DEPARTMENT OF ENVIRONMENTAL QUALITY
 AIR QUALITY DIVISION
 ACTIVITY REPORT: Scheduled Inspection

FACILITY: DIAMOND CHROME PLATING INC		SRN / ID: A2931
LOCATION: 604 S MICHIGAN, HOWELL		DISTRICT: Lansing
CITY: HOWELL		COUNTY: LIVINGSTON
CONTACT: John Wagner, Director - Health, Safety & Environmental Affairs		ACTIVITY DATE: 09/19/2016
STAFF: Daniel McGeen	COMPLIANCE STATUS: Non Compliance	SOURCE CLASS: MINOR
SUBJECT: Unannounced, scheduled inspection.		
RESOLVED COMPLAINTS:

On 9/19/2016, the DEQ, AQD conducted an unannounced, scheduled inspection of Diamond Chrome Plating (DCP).

Image 6(Photo 6) : Blue vinyl tape on SH28, which connects to SH15.

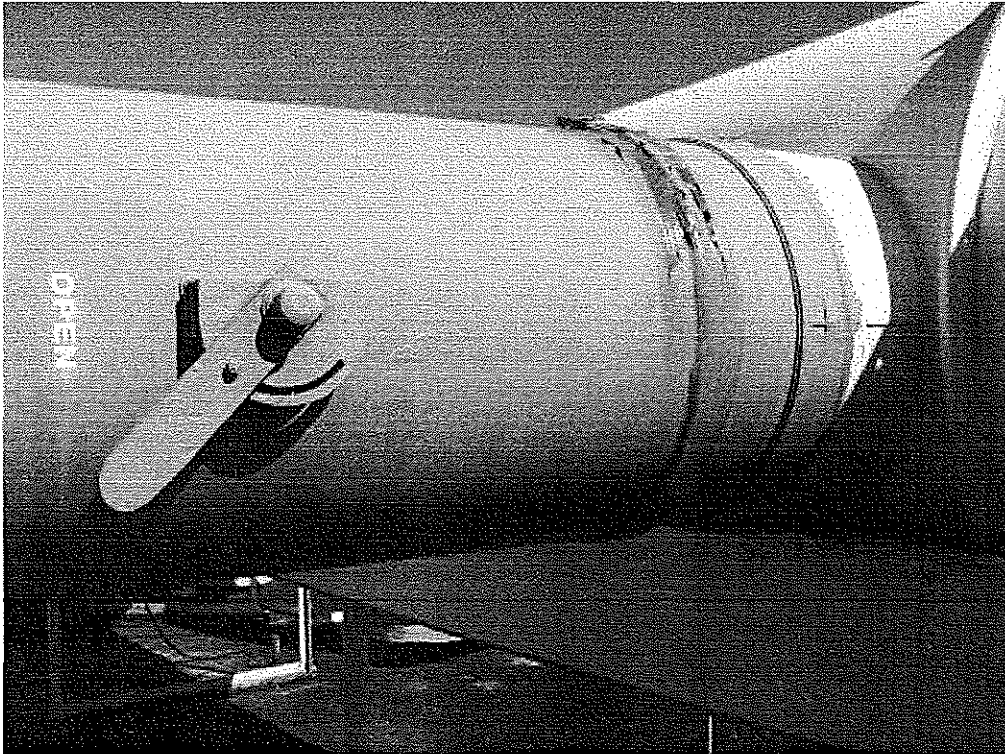
On an elbow-shaped section of gray painted ductwork, which connects to the white PVC ductwork for scrubber #3, I observed blue tape showing through peeling gray paint. It is my understanding that the gray vertical duct, V9, serves chrome tank 9, and comes up through the roof. V9 is joined to a gray horizontal section of ductwork, SH28, which in turn connects to the white 54 inch duct section SH15. The blue tape is on section SH28. Please see photos 6 and 7.

Mr. Wagner explained that this is not uncommon. He informed me the blue tape is vinyl, and is chemically resistant. He indicated that it is used for various purposes throughout the plant, including masking of parts about to be chrome plated. He informed me that it is probably used in other locations on the roof, and it does not leak. He drew my attention to vertical duct V9 (labeled as exit point 41 for the roof diagram), where blue vinyl tape had been applied, and then painted over, please see photos 8 and 9. He added that it is a fairly quick method for making repairs, whereas plastic welding is a more complex process, and it is not as quick a method for repairs.

Rule 910 requires that an air-cleaning device shall be installed, maintained, and operated in a satisfactory manner and in accordance with the administrative rules and existing law. There did not appear to be a violation of Rule 910 here, as the ductwork with the vinyl tape appeared to be free of chromic acid leaks and/or stains. Additionally, the tape was not peeling, and no ductwork seams were exposed.

Image 10(Photo 10) : Twin 24" extruded ducts for scrubber #4.

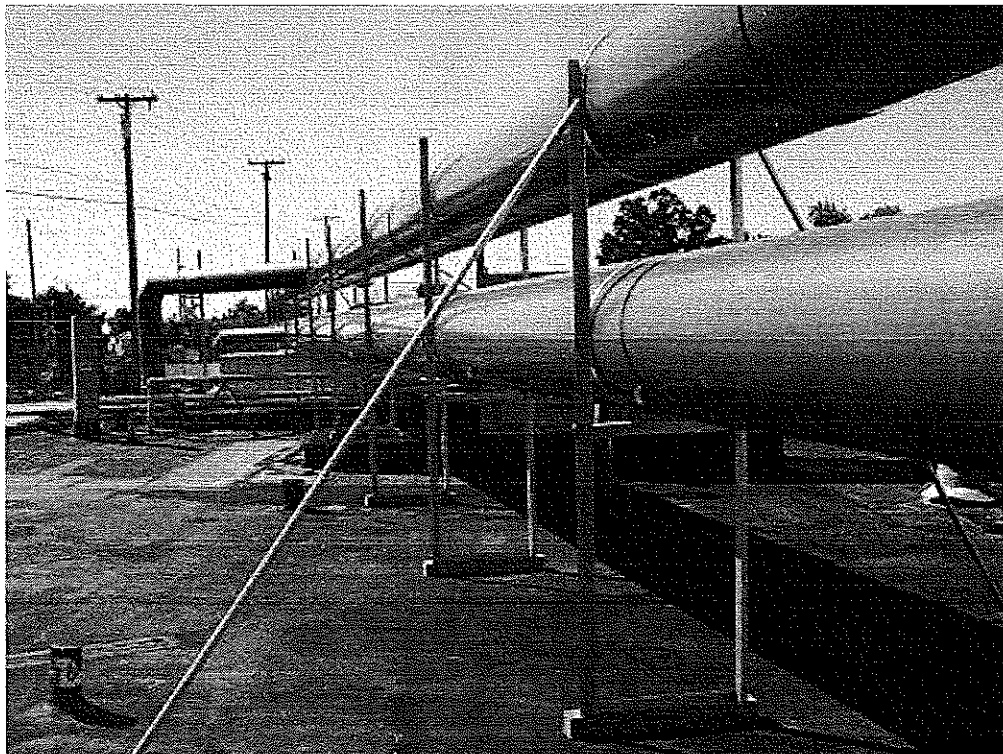
Mr. Wagner explained that DCP had hoped to replace the 54 inch diameter white PVC plastic ductwork leading up to scrubber #3 with twin, extruded 24 inch diameter ductwork this year, like they did in October 2015 for the 54 inch diameter ductwork leading up to scrubber #4. He informed me that unexpected expenses in other environmental areas have put that project on hold, for now. This new 24 inch ductwork from October was free of leaks. Please see photo 10.
